SERVICE BULLETIN

ENGINE – STAGE 1 TURBINE NOZZLE ASSEMBLY AND HP TURBINE ROTOR AND STATOR ASSEMBLY –
REPLACEMENT OF THE STAGE 1 HPT DUCT SEGMENT AND THE STAGE 1 HPT AIRSEAL – CATEGORY
CODE 7 – MOD.ENG-72-0013

V2500-ENG-72-0013

Fig.1

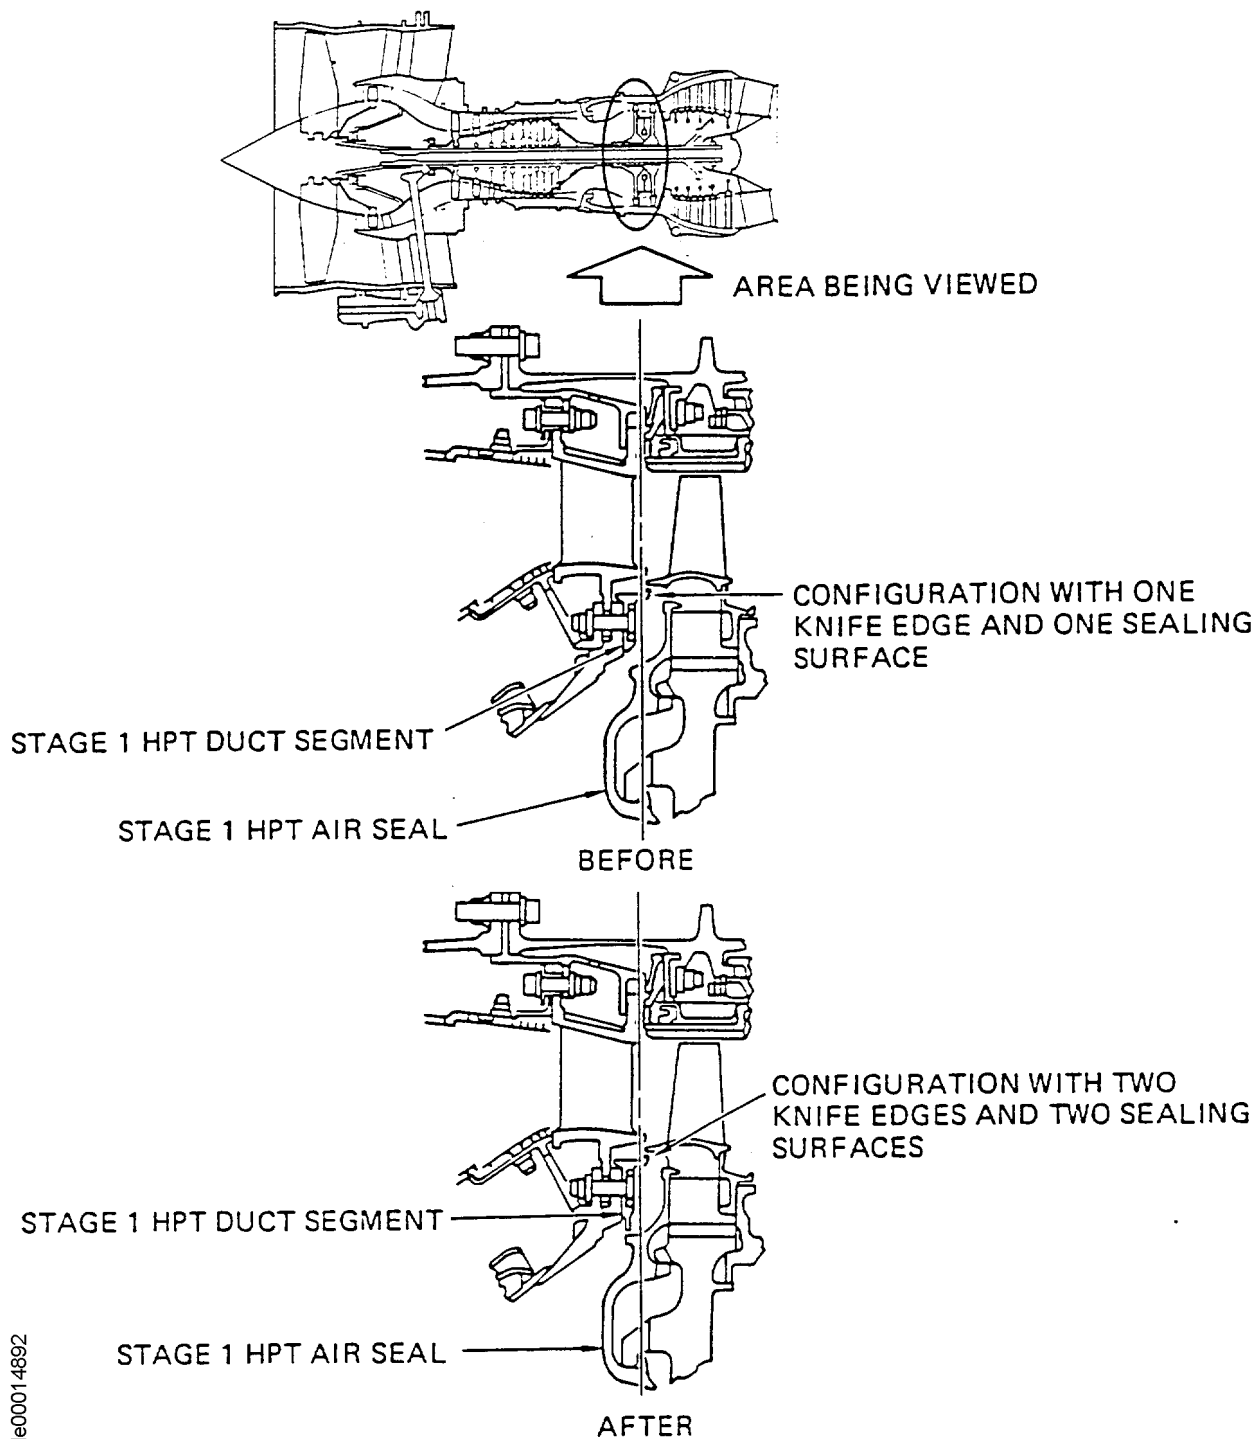
(1) The 1st stage cavity temperature and weight is reduced as follows:

(a) An additional sealing surface is added to the Stage 1 HPT Airseal (Outer). Refer to Figure 1.

(b) An additional seal is added to the Stage 1 HPT Duct Segment. Refer to Figure 1.

Location of stage 1 HPT duct segments
Fig.2

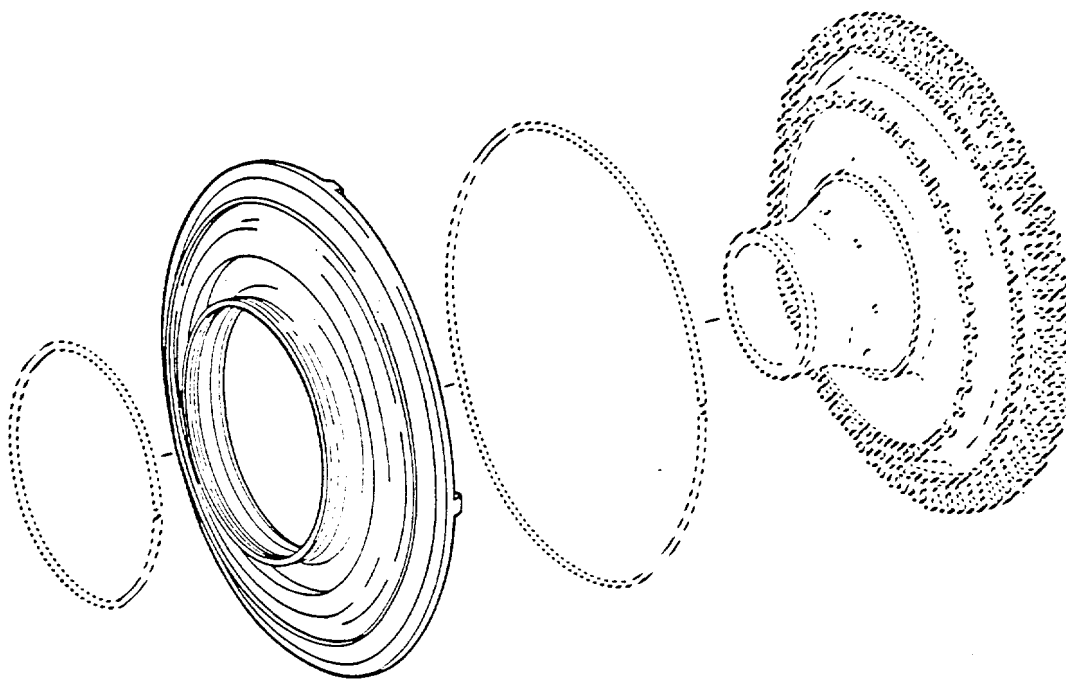
- (1) Install the PN 2A1198 Duct Segments (20 off) in the Stage 1 Turbine Nozzle Assembly by use of the approved procedures in Reference (2) Chapter/Section 72-44-00, Assembly. Refer to Figure 2.
- (2) Change the Assembly Part Number which is on the Turbine Nozzle Group from PN 2A1200 to PN 2A0600. Use the approved procedures in Reference (3), 70-09-00, Marking of Parts.

NOTE: You can use the PN 2A1271 Stage 1 HPT Air Seal with the PN 2A0087 or PN 2A1198 Stage 1 HPT Duct Segments.

The PN 2A0488 Stage 1 HPT Air Seal cannot be used with PN 2A1198 Stage 1 HPT Duct Segments because there will be interference.

Location of stage 1 HPT air seal
Fig.3

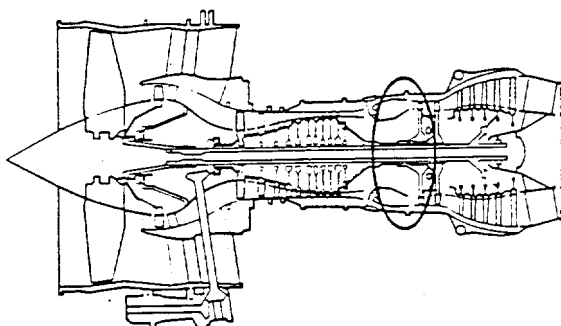
- (3) Install the PN 2A1271 Stage 1 HPT Air Seal (1 off) in the Stage 1 Turbine Rotor Assembly. use of the approved procedures in Reference (2), Chapter/Section 72-45-10, Assembly. Refer to Figure 3.
- (4) Change the Assembly Part Number which is on the Stage 1 Turbine Rotor Assembly from PN 2A1021 to PN 2A1621. Use the approved procedures in Reference (3), 70-09-00, Marking of Parts.
- (5) Assemble the HPT Module Rotor and Stator Assembly by use of the approved procedures in Reference (2), Chapter/Section 72-45-00 Assembly.
- (6) Change the Assembly Part Number which is on the HPT Module Rotor and Stator Assembly from PN 2A1300 to PN 2A0400. Use the approved procedures in reference (3), 70-09-00, Marking or Parts.

REPLACE THE PN 2A0488 STAGE 1 HPT
AIR SEAL (1 Off) OR PN 2A1105 STAGE 1
HPT AIR SEAL (1 Off) WITH PN 2A1271
STAGE 1 HPT AIR SEAL (1 Off)
